# Technical Service Information

## **FORD 4R44E/4R55E DELAYED FORWARD ENGAGEMENT**

Figure 1

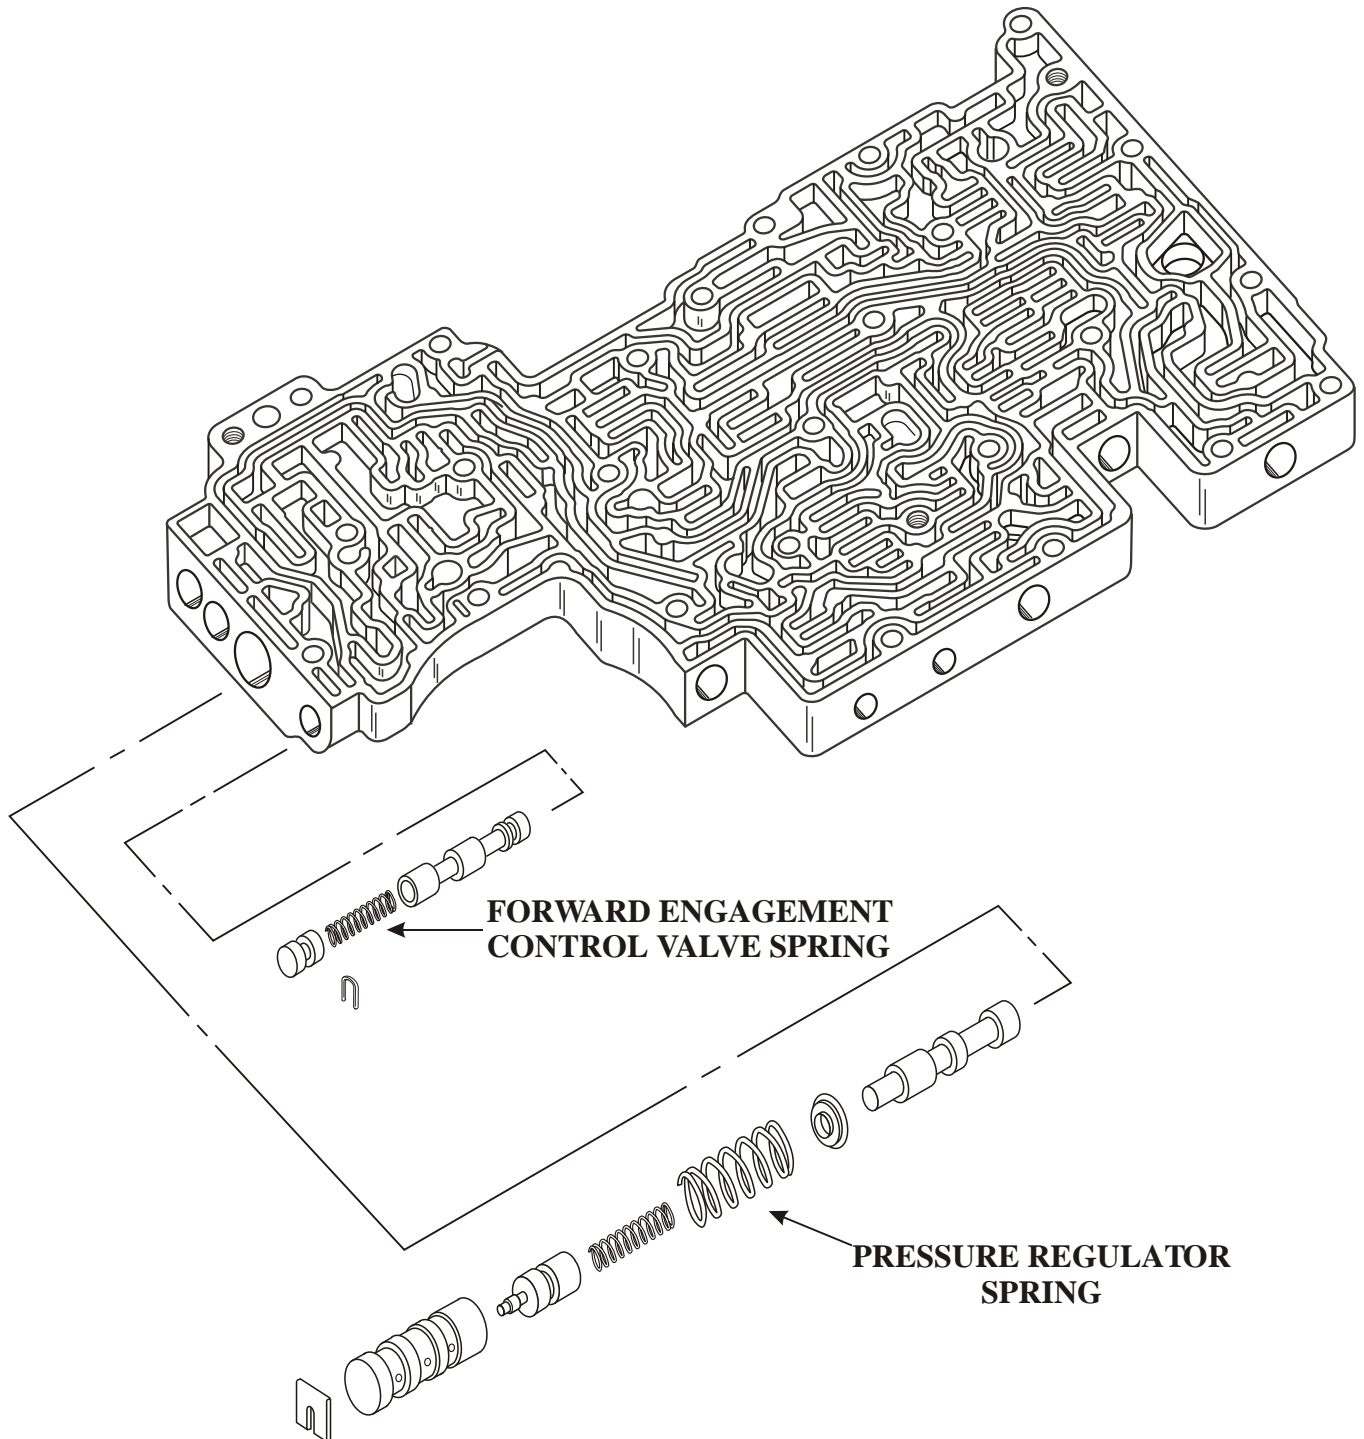
**COMPLAINT:** Some vehicles equipped with the 4R44E/4R55E may exhibit a delayed forward engagement condition.

**CAUSE:** One cause may be, an insufficient volume of oil fed to the forward clutch circuit.

**CORRECTION:** (1) Remove and discard the forward engagement control valve spring as shown in Figure 1.  
Replace the pressure regulator spring with a yellow pressure regulator spring from  
(2) the valve body of an A4LD transmission as shown in Figure 1.

**NOTE:** If the yellow pressure regulator spring from an A4LD valve body is not available, some aftermarket A4LD valve body kits contain a **PURPLE** pressure regulator spring that can be used in place of the yellow A4LD pressure regulator spring.
